Col. E. Brooke Lee Middle School, Mandatory Referral, MR 2020007

Completed: 12/24/2019

Mandatory Referral for the construction of a new Col. E. Brooke Lee Middle School, to replace the existing school that was built in 1966, with a new 178,000 square foot facility to allow for an enrollment capacity of up to 1,200 students.

Figure 2: Proposed Site Plan for the new Col. E. Brooke Lee Middle School

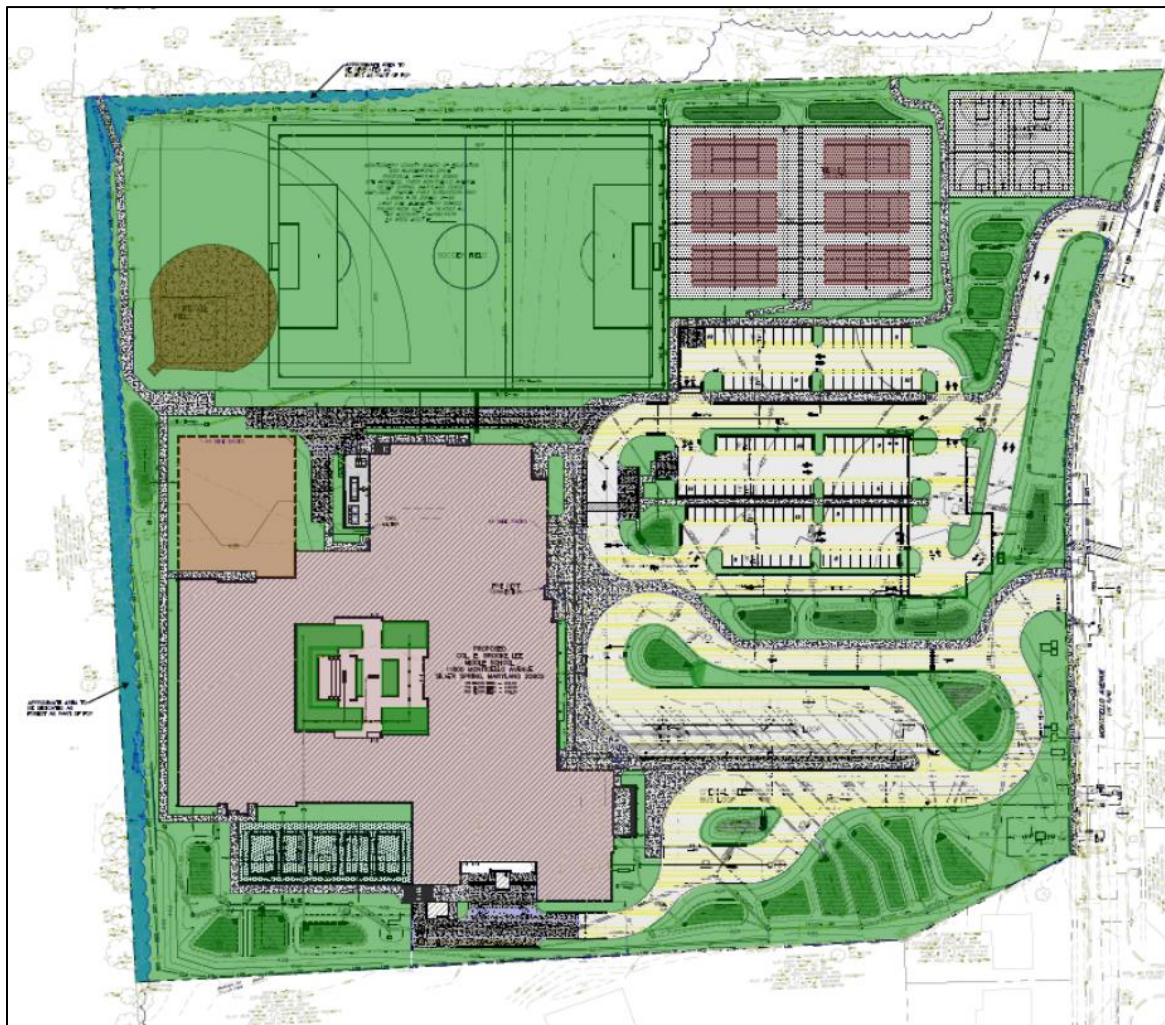
- Provide a sidewalk connection, south of the proposed basketball courts, that provides a direct connection to Wheaton Regional Park from Monticello Avenue.
- The applicant must obtain a Parks Department Construction Permit for any construction that impacts Wheaton Regional Park.
- The applicant will construct two trail connections from the middle school to the Wheaton Regional Trail system.
- All proposed athletic fields must be constructed to Montgomery Parks' standards and specifications.
- Prior to construction, MCPS must receive a Final Forest Conservation Plan from the Planning Board.
- The applicant must receive a Stormwater Concept Plan approval from the Department of Permitting Services (DPS).

Figure 5: Proposed Pedestrian Improvements/Connections to Wheaton Regional Park

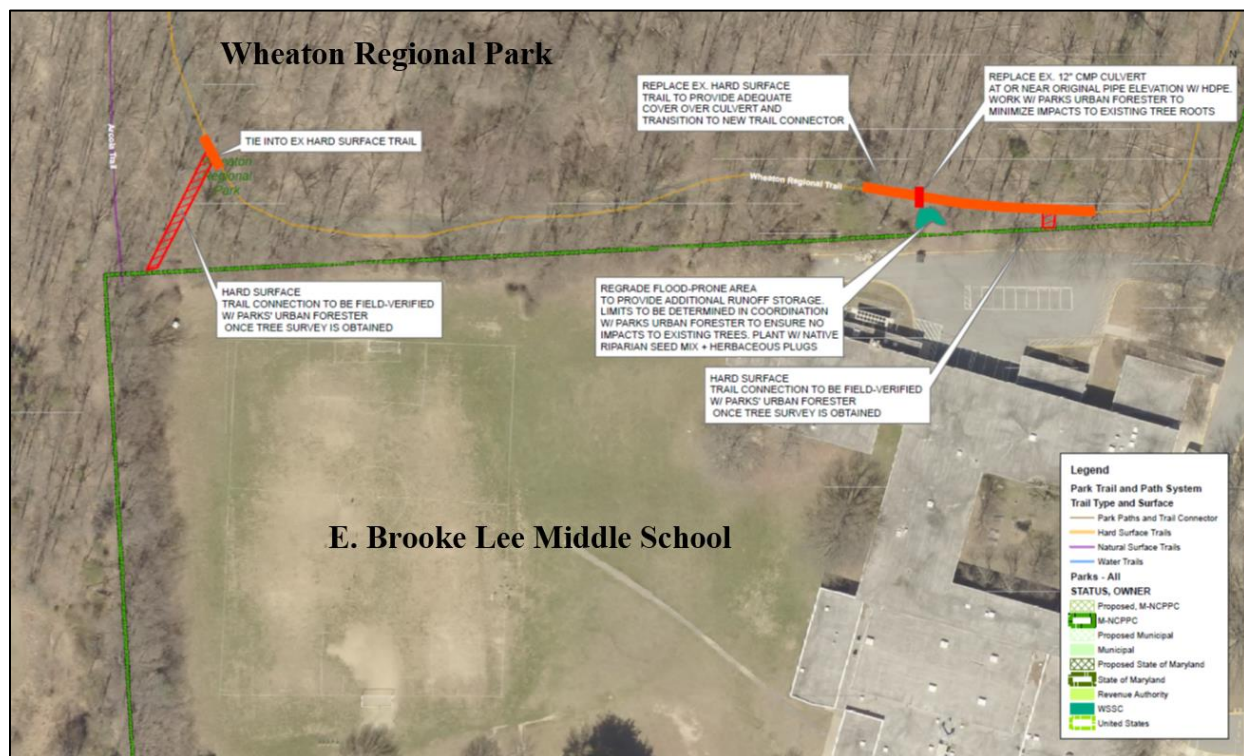
If any future design alterations result in impacts to adjacent forest resources, Parks will require that trees removed be replaced on an inch per inch basis or at a rate of \$100/inch. Impacted trees will be

calculated at a rate of half their Diameter at Breast Height (DBH) for replacement. For safety reasons, any hazardous trees identified on park property adjacent to the proposed building location will need to be removed before construction is complete.

- Any trees along the park boundary between the school and Wheaton Regional Park, which are impacted by construction grading or access, as determined by the Parks Arborist, will be removed and mitigated onsite.
- MCPS should continue to work with the Parks Department to minimize impacts to existing park resources and enhance connectivity between the two sites.
- Hard surface trail connections to Wheaton Regional Trail will be designed and permitted by the Parks Department and constructed by MCPS prior to the school completion.
 - The trail connection will include new trail segments, smooth transitions into the existing trail network, a trail culvert replacement, and minor grading to accommodate site runoff onto parkland.
- Design efforts should strive to minimize storm water runoff onto adjacent parkland.
